| 8802-3/802.3 REVISION REQUEST 1122 |

REQUESTED REVISION:
STANDARD: IEEE Std. 802.3-2002
CLAUSE NUMBER: 28C.7
CLAUSE TITLE: Message Code #6--PHY identifier tag code

Clarification of OUI usage

Figure 28.1—Message code #6 sequence

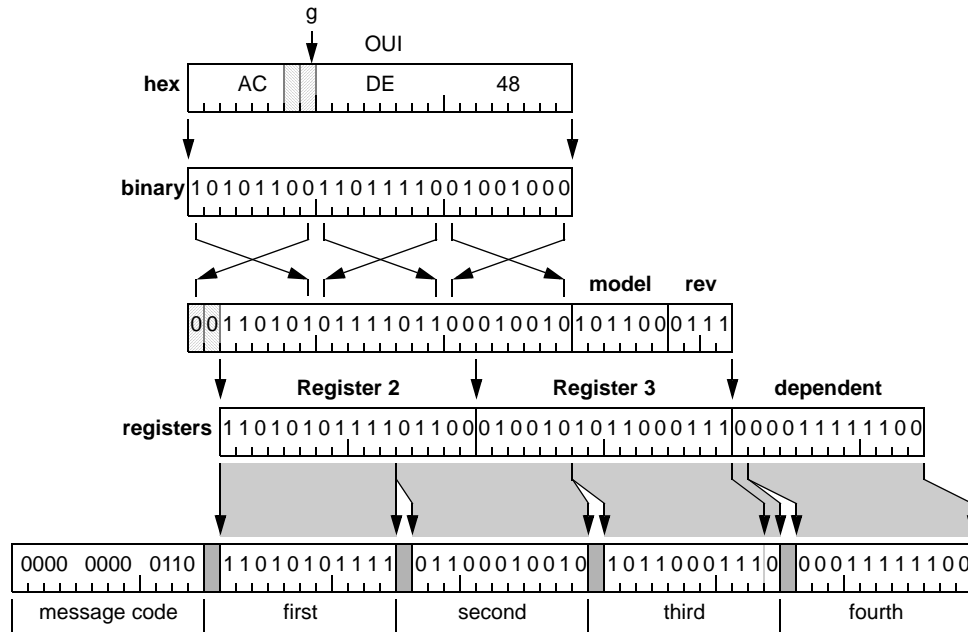
- 1) Bit-specification wording is very hard to follow; a figure is needed.
- 2) The bit ordering within-byte ordering is different from the IEEE/RAC usage, and should therefore be very clearly illustrated.

The PHY ID tag code message shall consist of a single shall consist of a single message code of 0000 0000 0110₂ followed by four user codes. For example, assume that a manufacturer's IEEE-assigned OUI value is AC-DE-48, the manufacturer's model number is 101100₂, manufacturer's revision number is 0111₂, and the PHY-dependent information is 000011111100₂. The message codes generated from these values are encoded into four message codes, as specified in Figure 28.1. For clarity, the position of the global broadcast *g* is illustrated.
